VISUAL SITE INSPECTION REPORT - 2016

SOUTHERN INDIANA GAS AND ELECTRIC
A. B. BROWN GENERATING STATION
TYPE III RESTRICTED WASTE LANDFILL
WEST FRANKLIN, IN

ATC PROJECT NO. 170LF00318

DECEMBER 20, 2016

Drawing Title:	SITE PLAN A.B. BROWN GENERATING STATION
Sheet:	1

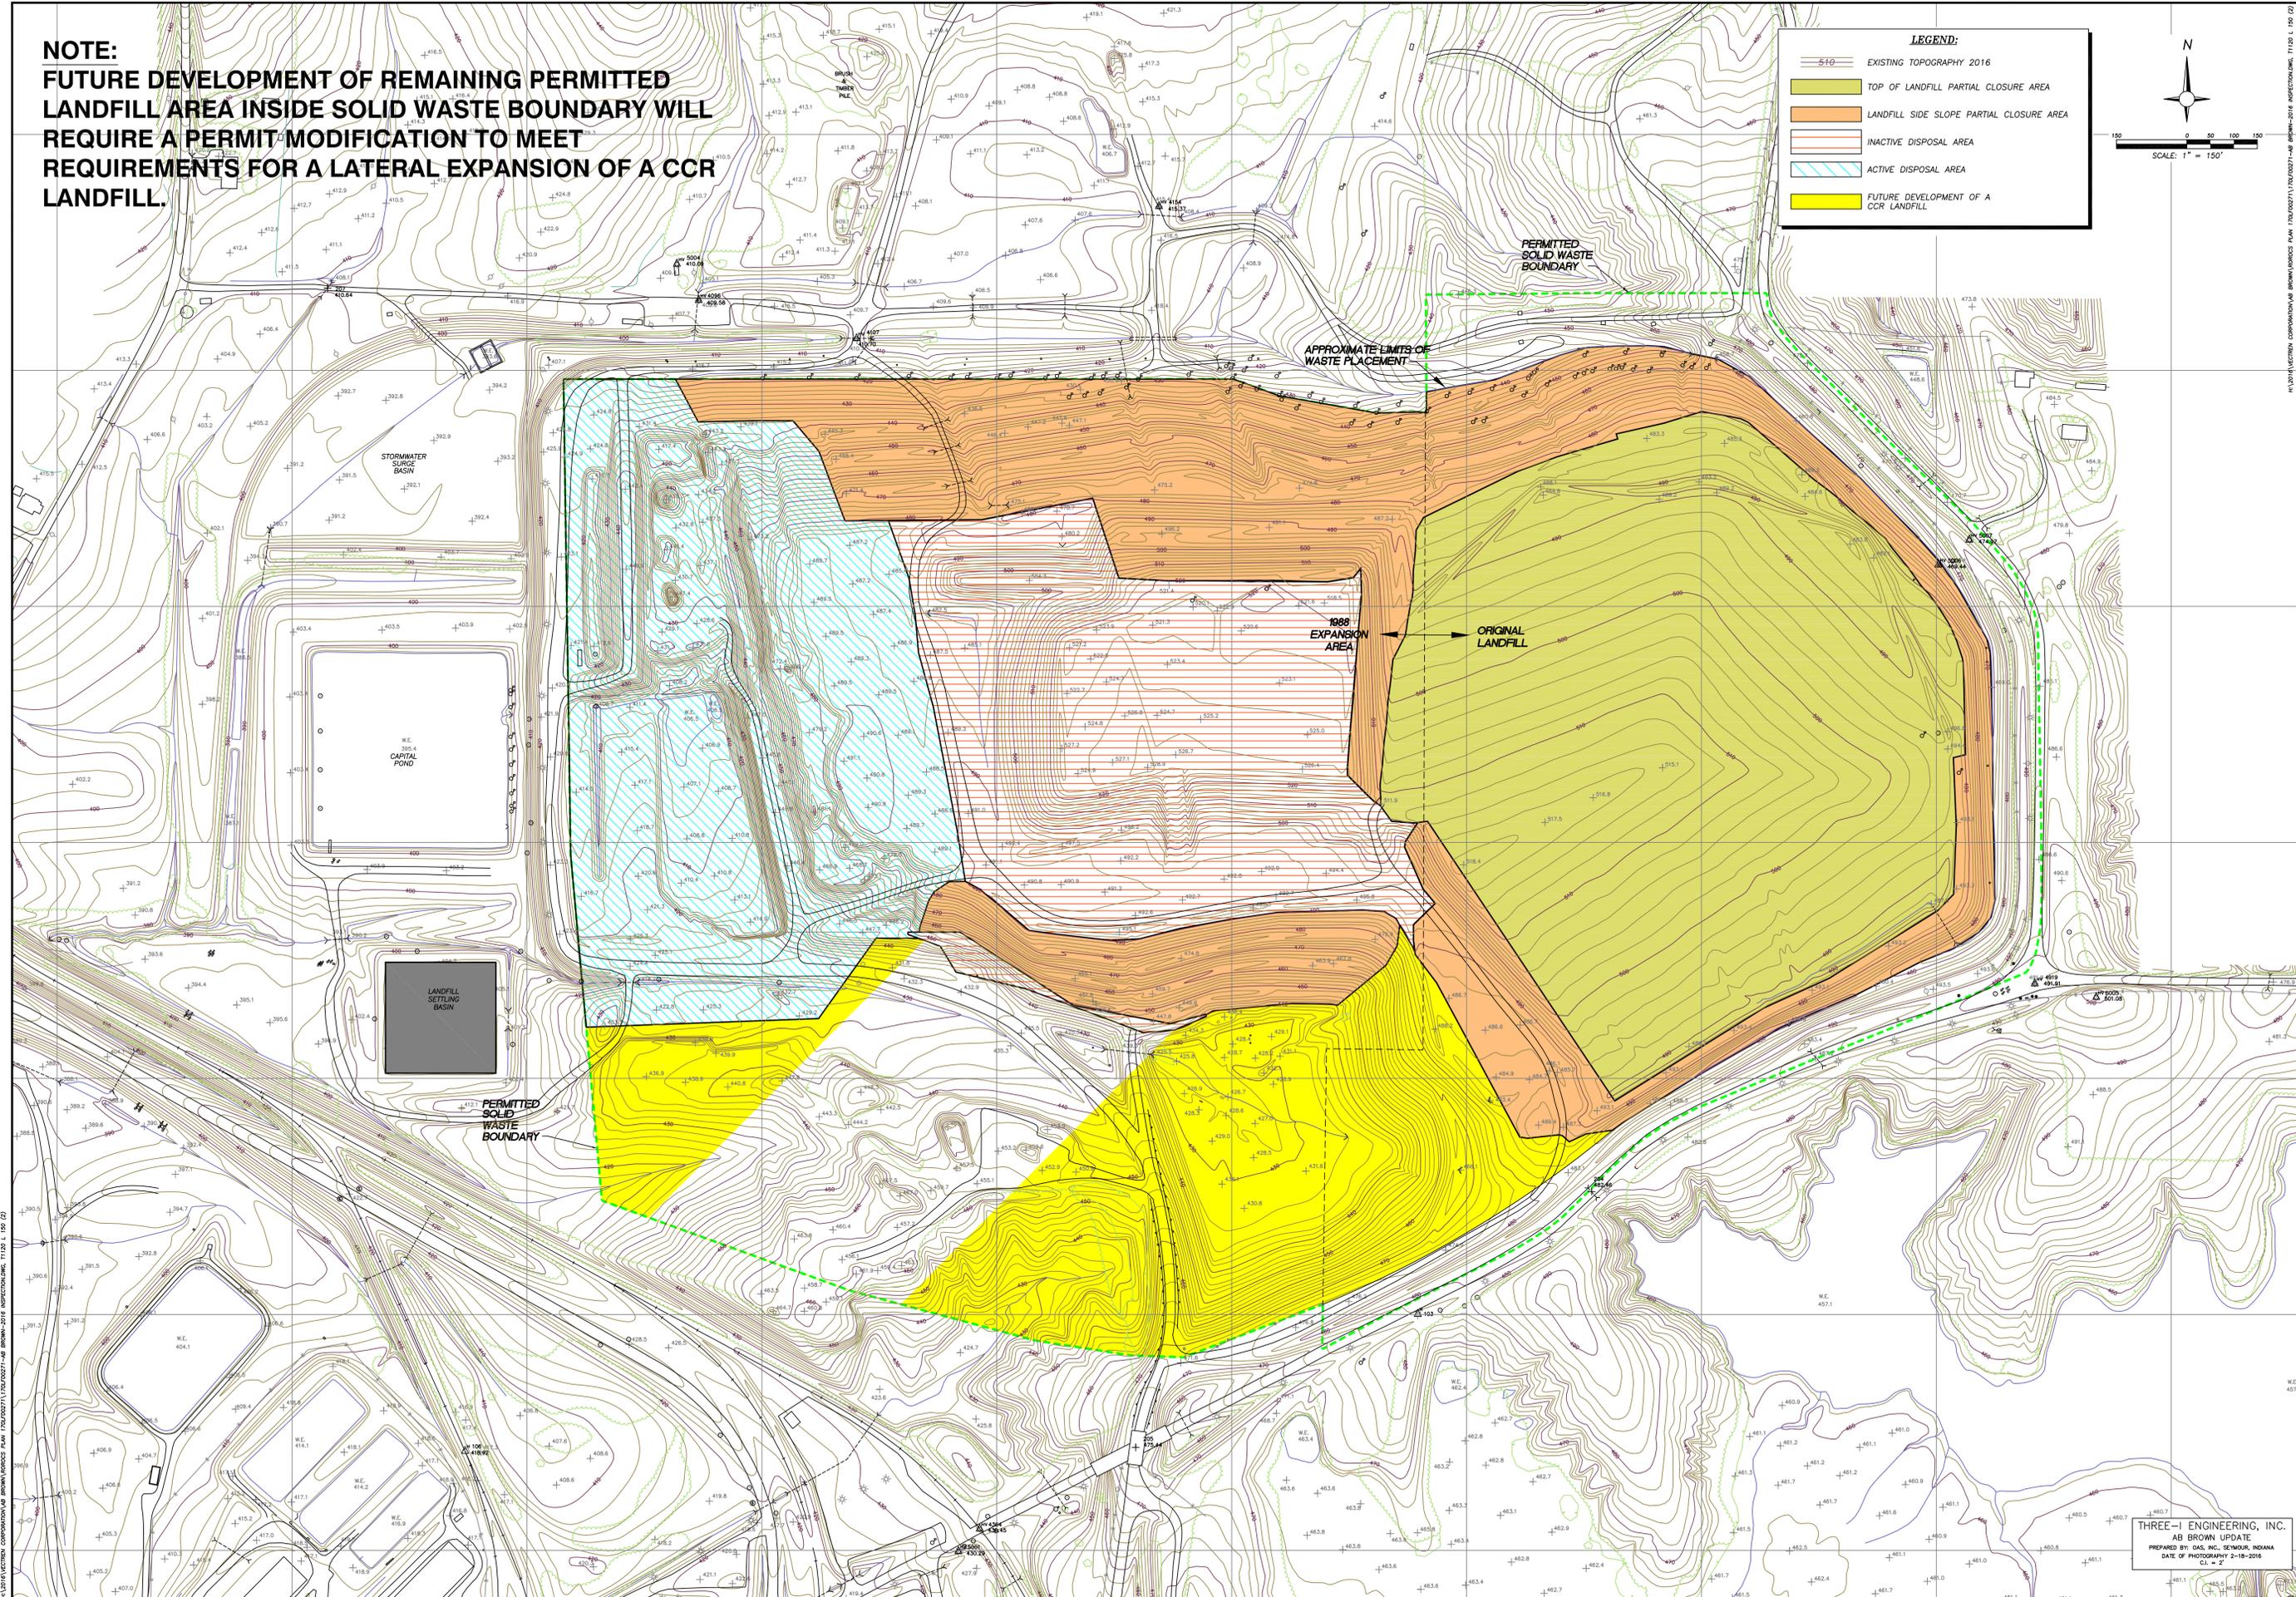
The approximate limits of each of these areas is noted on Sheet 1 in Appendix A. The following paragraphs include a summary of the observations made during the inspection followed by our recommendations in bold print.

The final cover on the perimeter slopes noted on Sheet 1 in Appendix A consists of a minimum of 24 inches of cohesive soils, covered with 0.5 ft of topsoil. The approximate limits of the 24.5 acre closed portion of the slopes is noted on Sheet 1 in Appendix A. Documentation of the completion of the closure activities along these slopes was submitted to IDEM in 2015. Items noted during the visual inspection of this area are described in the following list.

- 2) Several surface depressions/erosion features have formed in areas both adjacent to riprap downchute channels, along the flow line of the diversion berms and over downrain pipes. One such depression, located on the north side of the landfill, west of the north-south haul road on the backside of the upper level berm is approximately 6-feet long, 3-feet wide, and 2-feet deep.

- 4) Undercutting and erosion gully formation alongside one outlet pipe drainage structure near the base of the landfill in the vicinity of the perimeter ditch on the east side of the landfill.

- 5) The downrain pipes and the riprap lined downchutes on the north side of the landfill are generally in good condition. A collar connecting two segments of one of the downrain pipes has separated, causing the pipe ends to also separate.

- 7) Toe drain Riser Pipe #8, located on the north edge of the landfill adjacent to the perimeter ditch, is cracked and was seeping at the time of this inspection. Additionally, some seepage was noted along the north side of Manhole #12. Further, the water level in other manholes located upstream of these two locations appeared to be higher than normal. The facility was made aware of these issues at the time of inspection and arrangements were immediately made to remove the apparent blockage and flush the toe drain lines. Based on correspondence from the facility following the inspection, it appears that the blockage has

- 10) There are seeps discharging from several locations on the south slope that collect in the valley (bowl) area. This includes seeps noted within the riprap lined downchute. The combined flow rate at the time of this visual inspection was estimated to be approximately 1 gpm. Standing water was noted at the toe of the slope and the area is generally covered with phragmites. At the time of this inspection, construction was in progress to modify an existing piping system to convey the seep water to the sedimentation basin. It is our understanding that the standing water noted at the toe of slope will be eliminated once that project has been completed.

The inactive disposal area noted on Sheet 1 in Appendix A generally consists of approximately 18 acres across the top of the central portion of the landfill. This area has not yet been filled to the approved final grades, although it has been covered with an intermediate soil cover and vegetated until filtercake placement resumes. Items noted during the visual inspection of this area are described in the following list.

- 3) A recently installed PVC drainage pipe wraps around the northwest corner of the active area and discharges to the east. The east facing outlet pipe has no vegetation cover for the outlet receiving area and is subject to erosion.

Recommendation: Fill depressions and either revegetate or apply additional riprap as needed. Monitor the repaired areas for the redevelopment of the depressions.

Recommendation: Backfill erosion gullies and add additional riprap protection to prevent further erosion.

Recommendation: Repair the pipe segment to properly direct outlet flow.

Recommendation: Continue a regular maintenance program on the toe drain lines to minimize the potential for development of blockages.

Recommendation: Continue to collect water discharging from the seeps and route to the Sedimentation Basin. In general, these seeps are located below the poorly drained portion of the inactive section of the landfill as described in Item # 2 in the following section of this report. Recommendations regarding the poorly drained area are also provided in the following section.

Recommendation: Monitor this area during wet season conditions. If surface water ponds in this area, modifications should be made to the grades in this area to promote surface water runoff.

Recommendation: Supplement the existing straw cover with erosion control mat or riprap to protect the unvegetated soil surface during storm events.
